PROFILE ALIGNMENT AND GRADE OF  
 SANITARY SEWERS PAGE 1  
 TO BE CONSTRUCTED IN

VERMONT AVENUE

PRIVATE CONTRACT NO. 8503

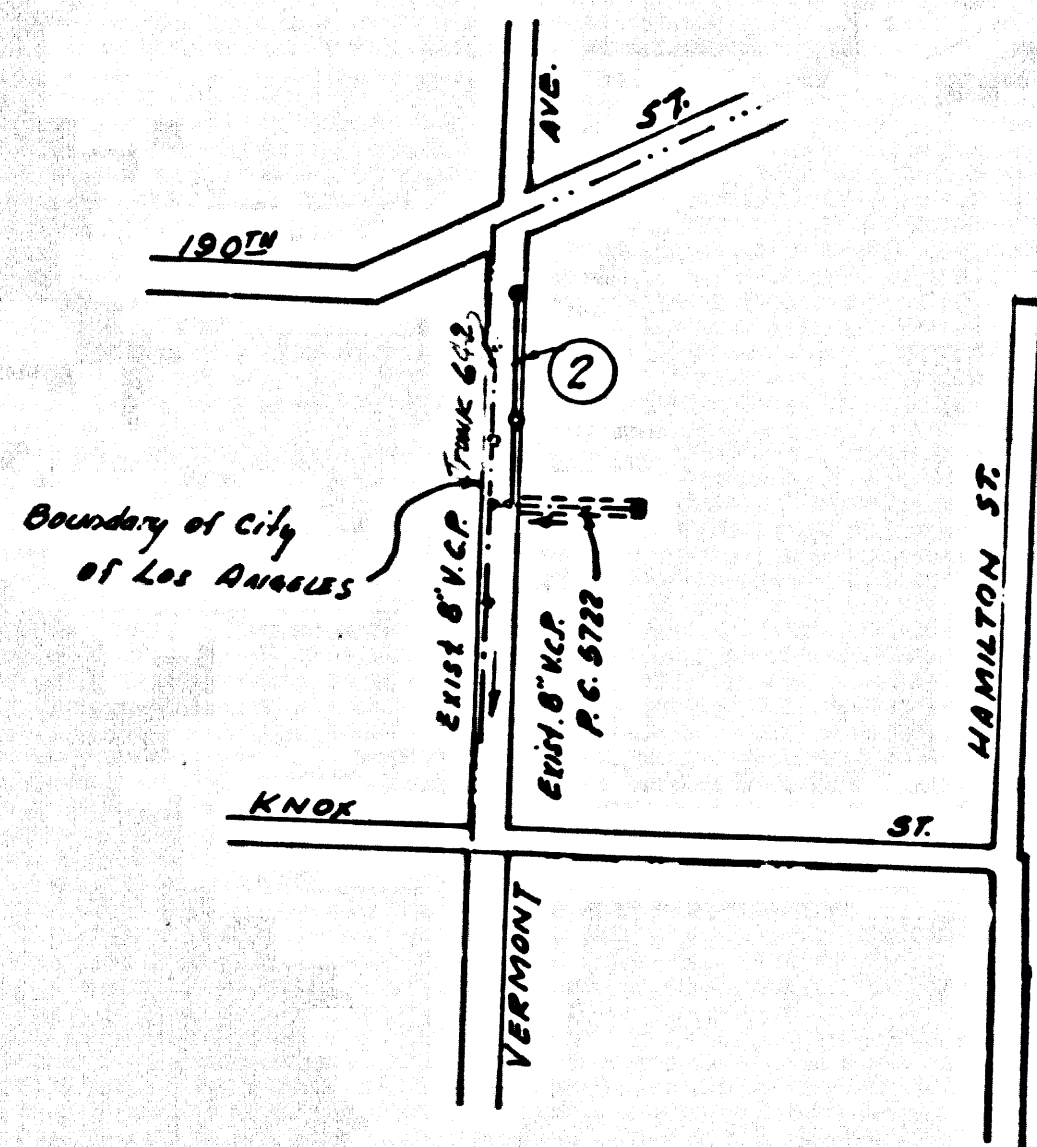
Revision 9/28/70  
 Moved M.H. from Sta. 5+22.50 to  
 Sta. 5+14.50 to avoid Tel. Conduit.  
 Approved By: *Charles J. Libbey*  
 10653 Reg. CE No.
